Option 1

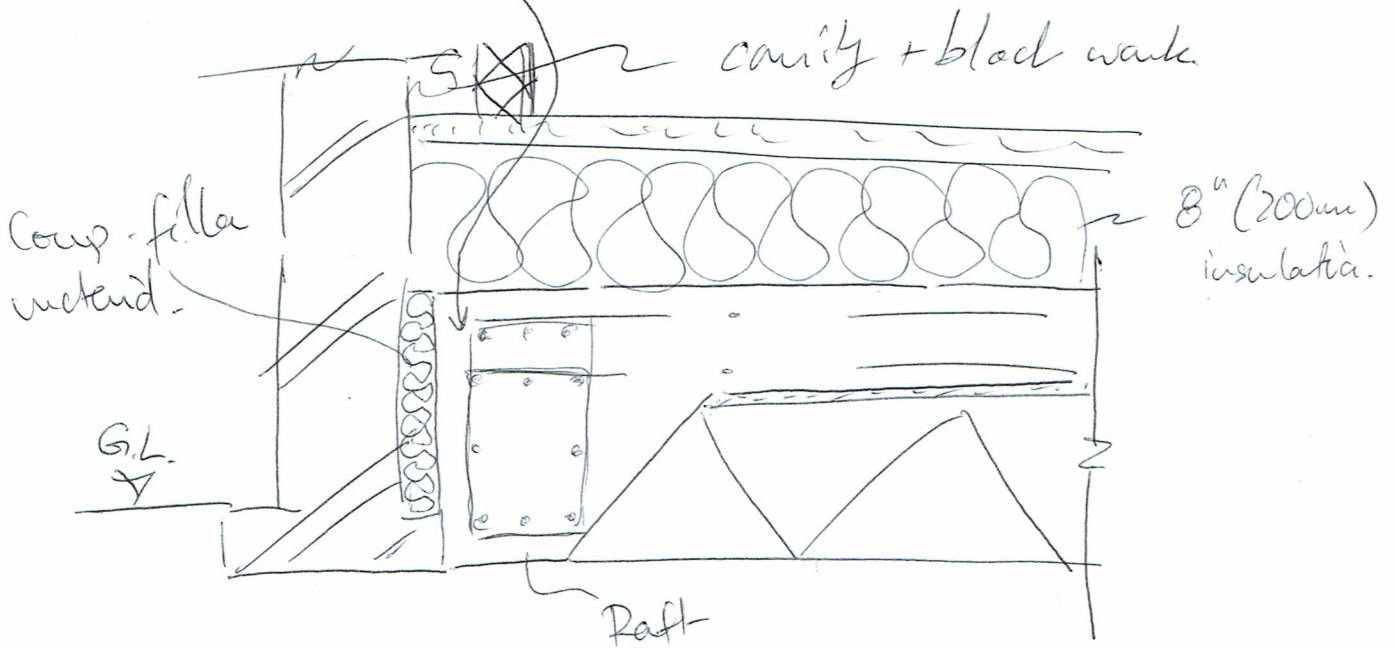
Or build flat reinforced slab? Take away this edge thickening.

Preferred option as raft is built off well compacted steel.
